ADDENDUM

December 15, 2017

RFB NO. 317028 - ADDENDUM NO. 1

SCHUMACHER BARN REMODEL/SITE IMPROVEMENTS (REBID)

1 GROUND FLOOR PLAN - FIRE PROTECTION
1/4" = 1'-0" NORTH

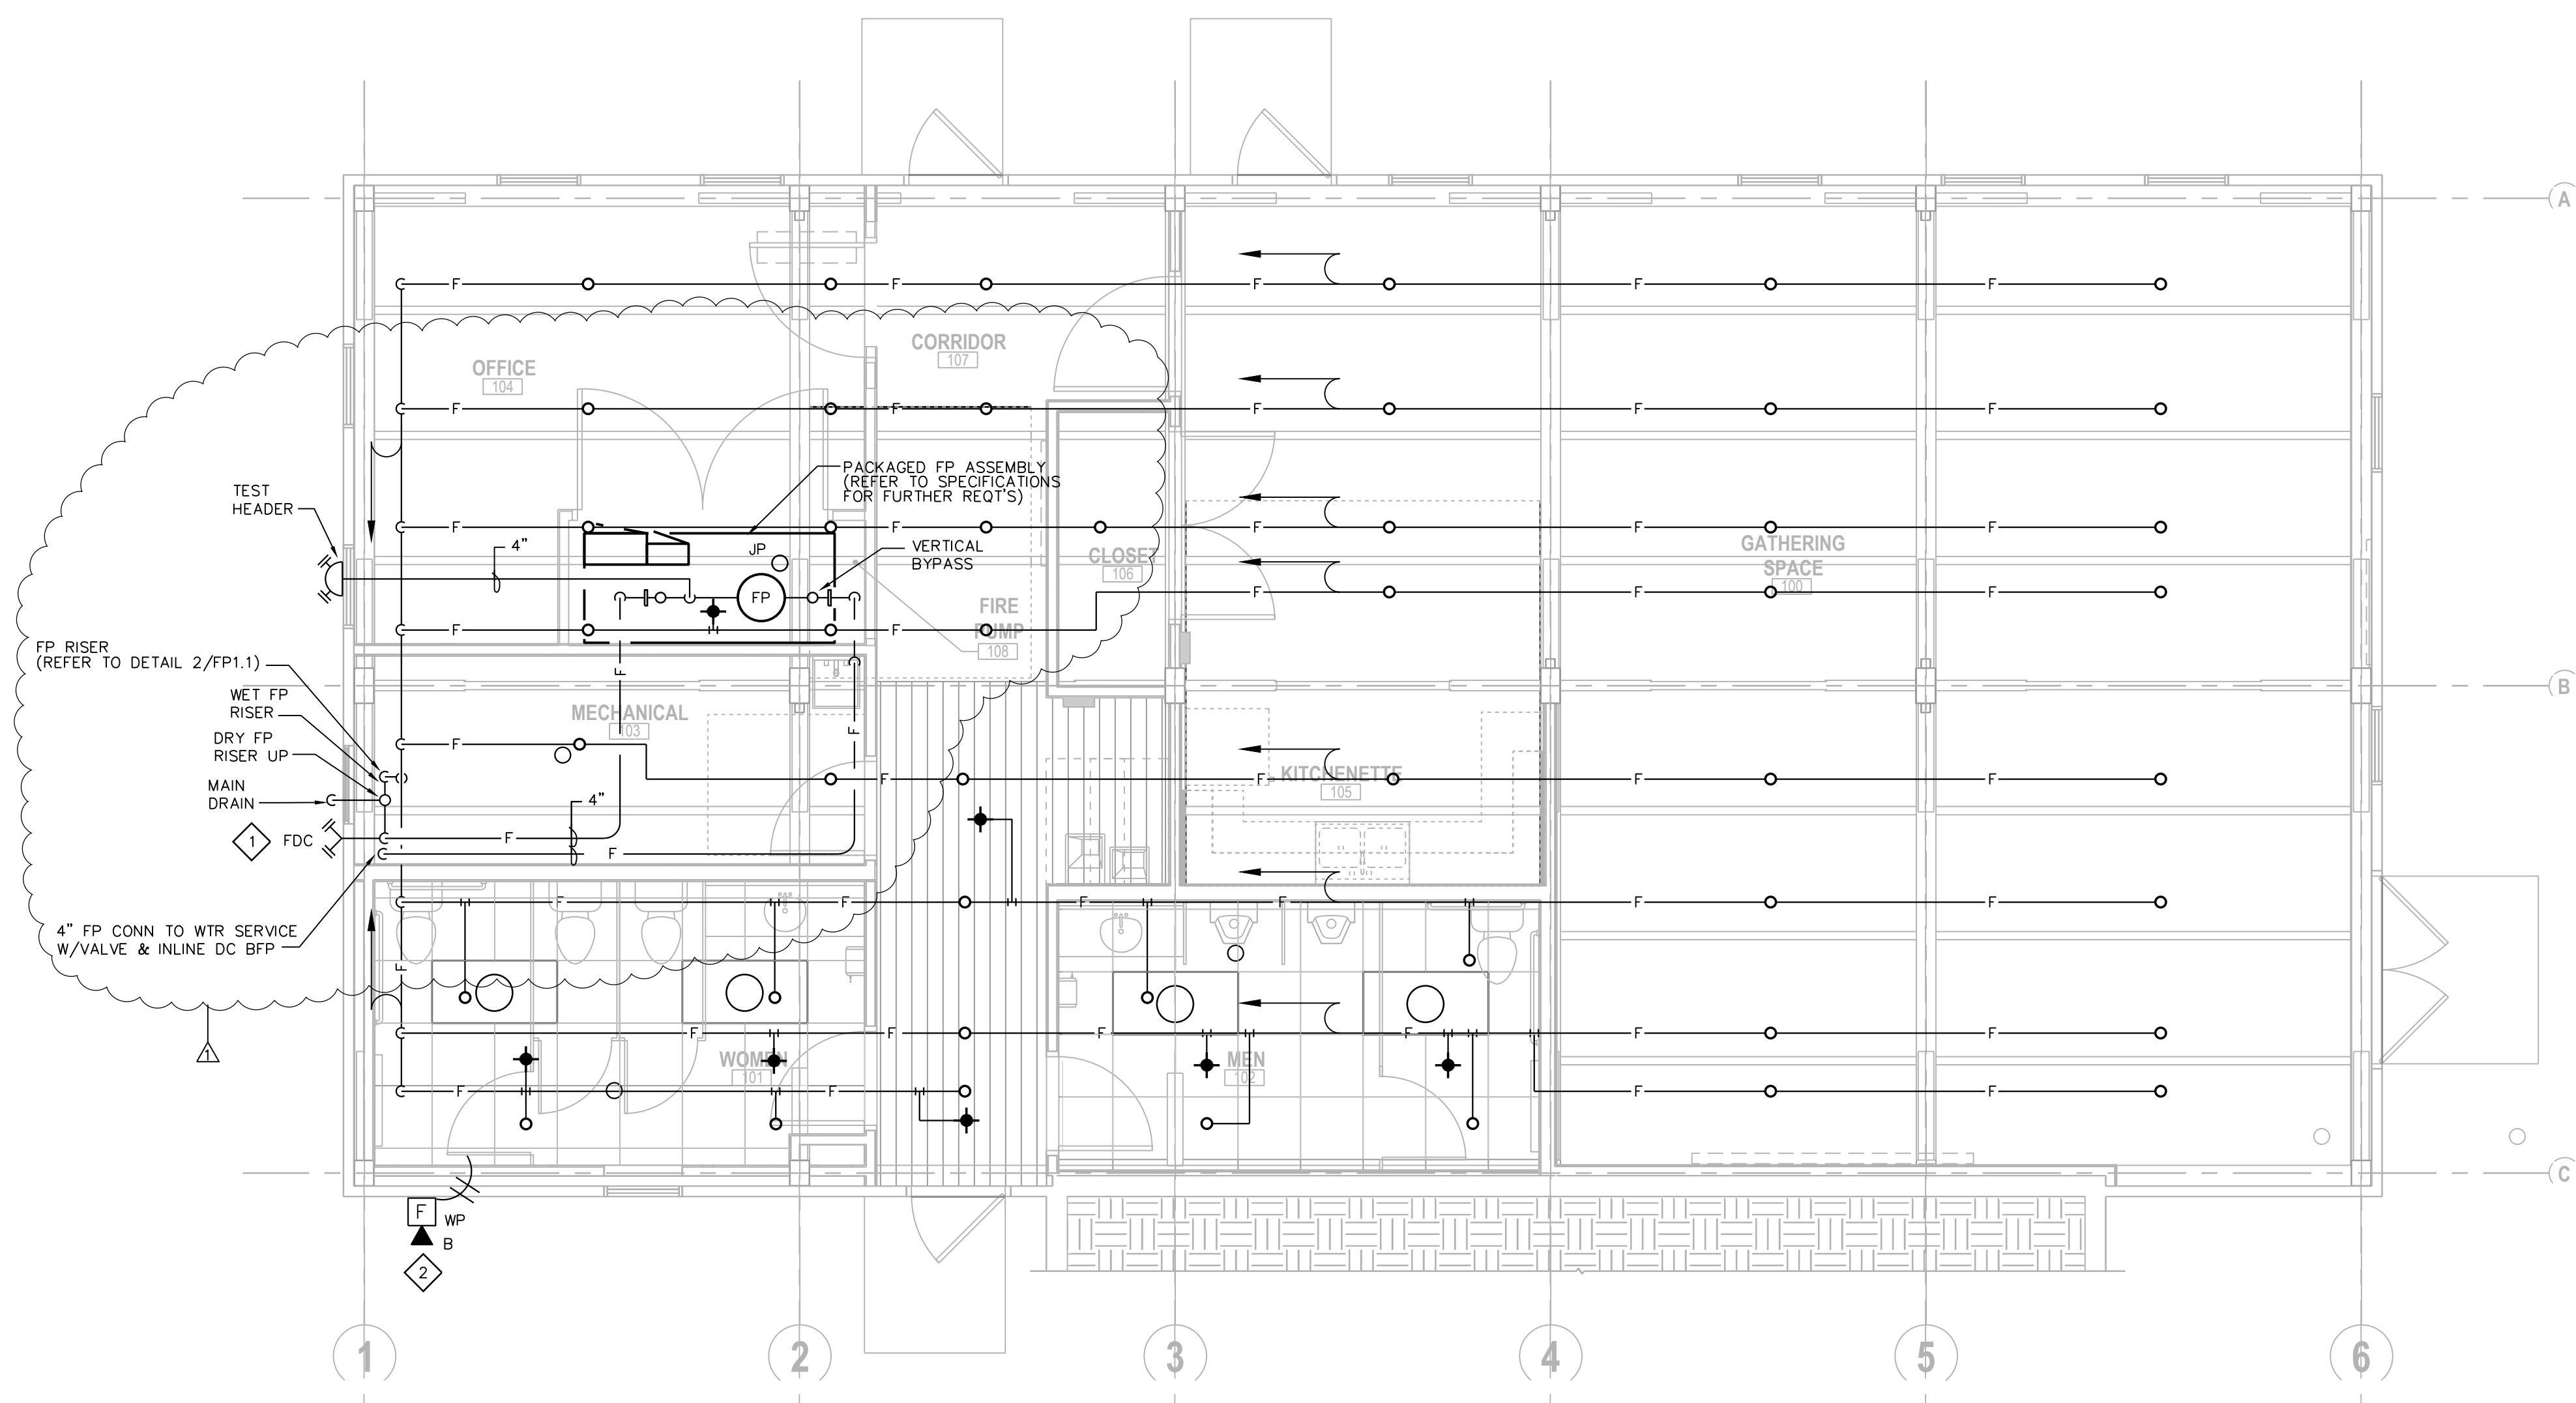
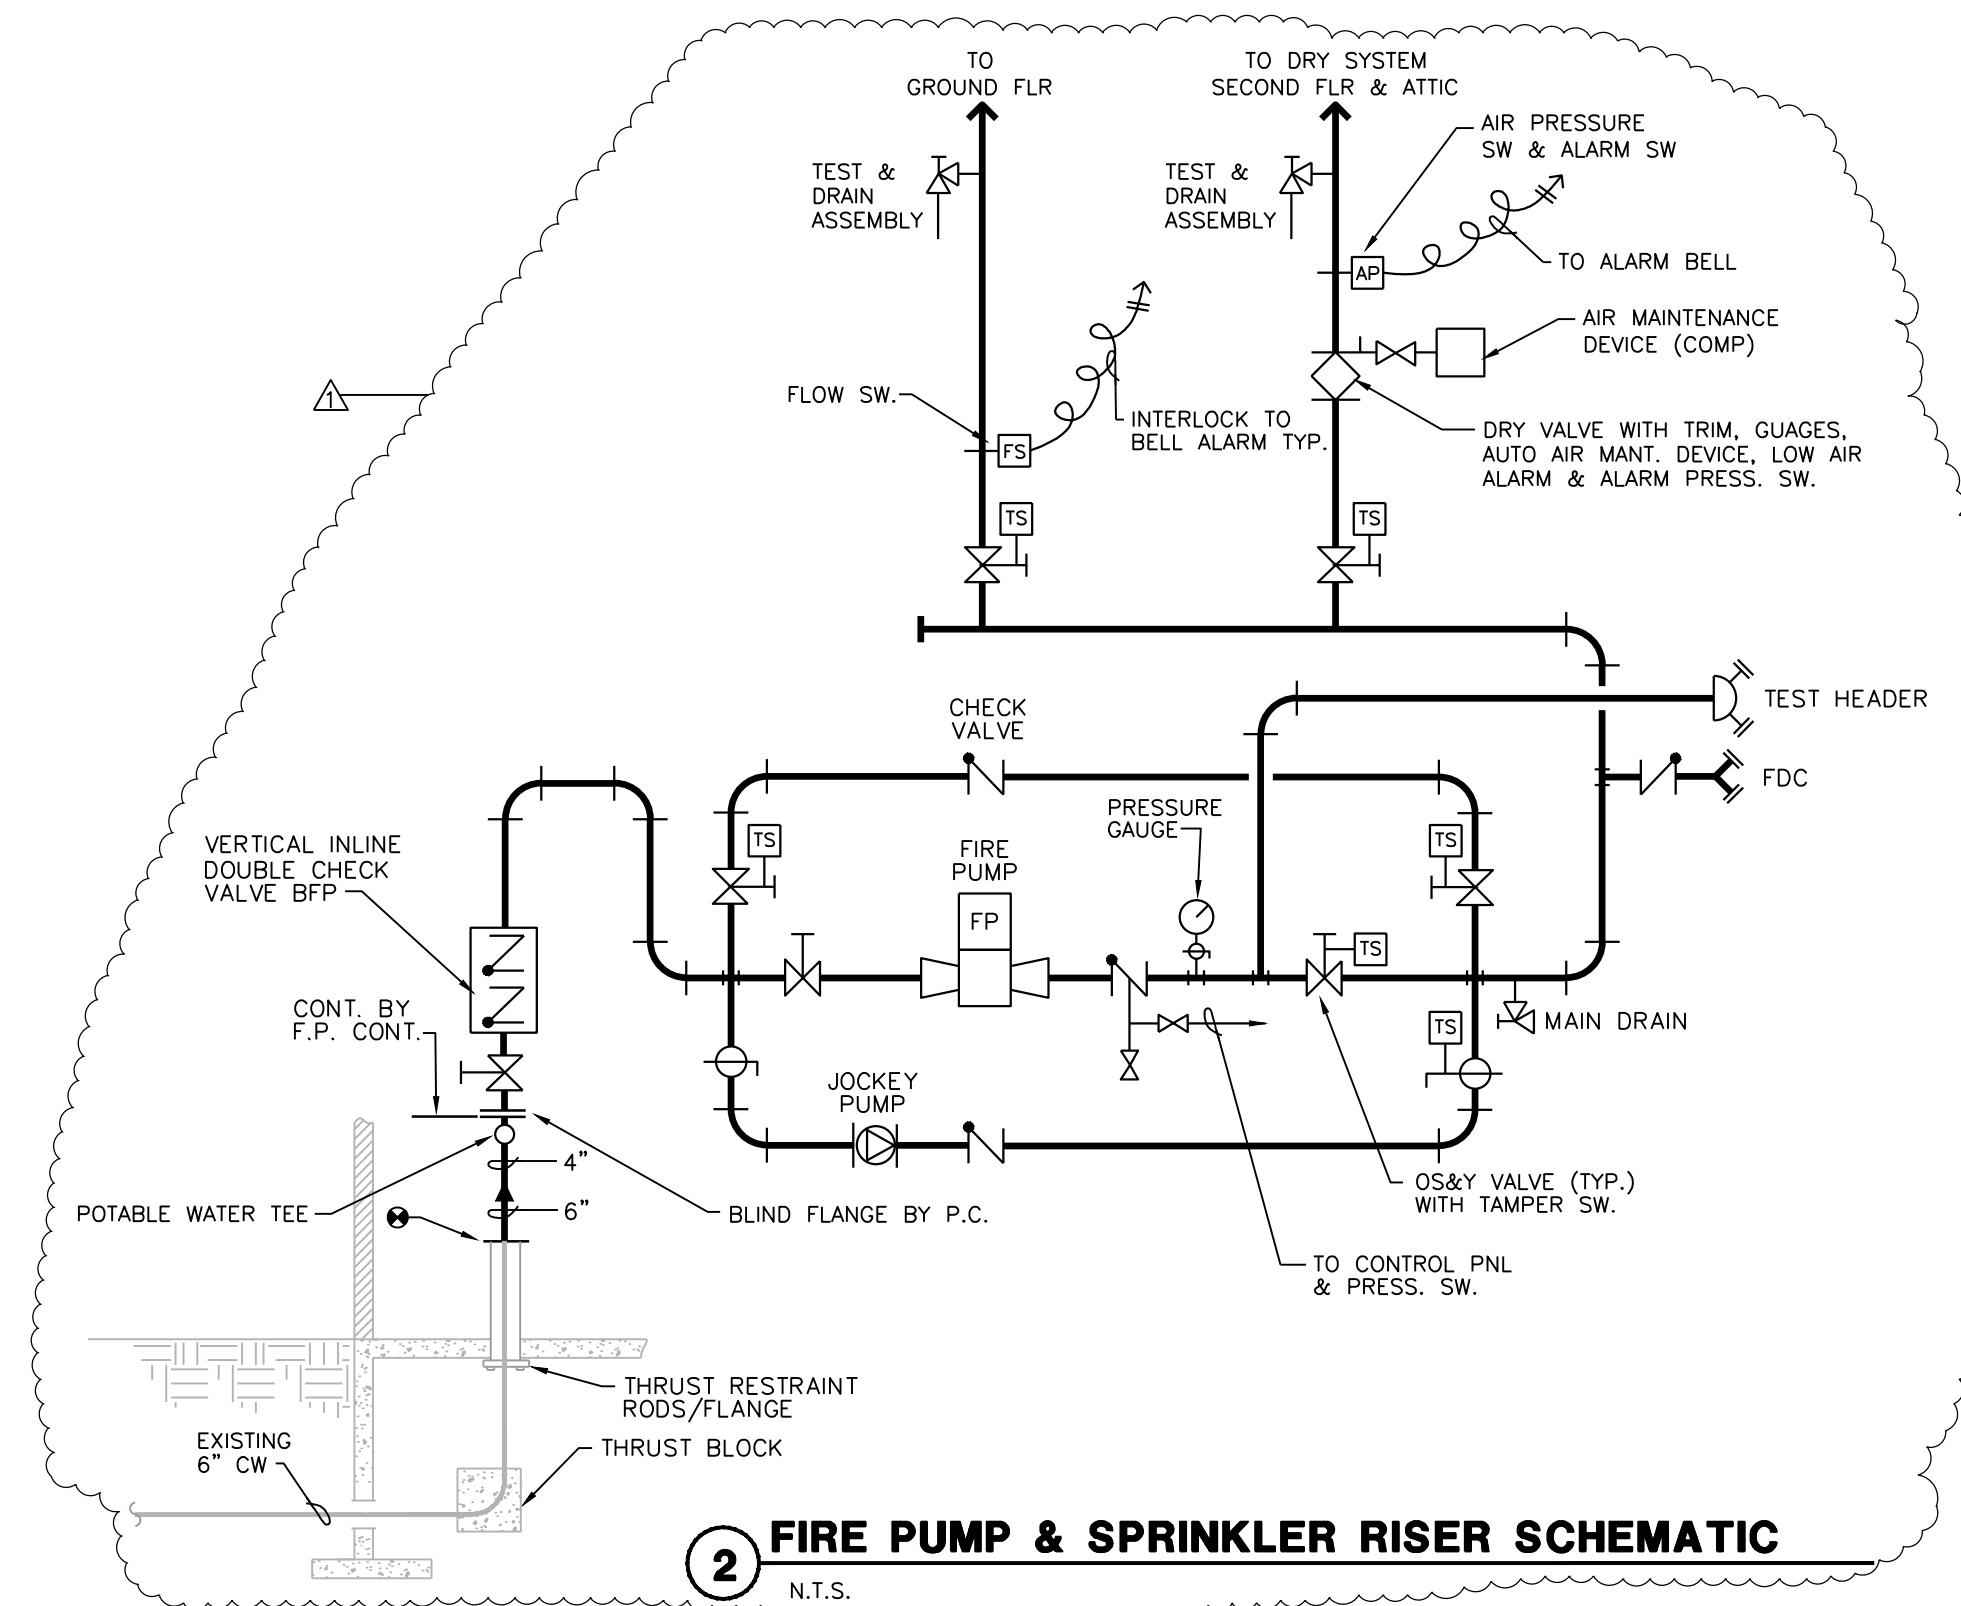
26. Sheet FP1.1 - GROUND FLOOR PLAN – FIRE PROTECTION

Delete current Sheet FP1.1 and replace with new Sheet FP1.1, issued with this Addendum
Added Fire Pump assembly in new room – Fire Pump 108.
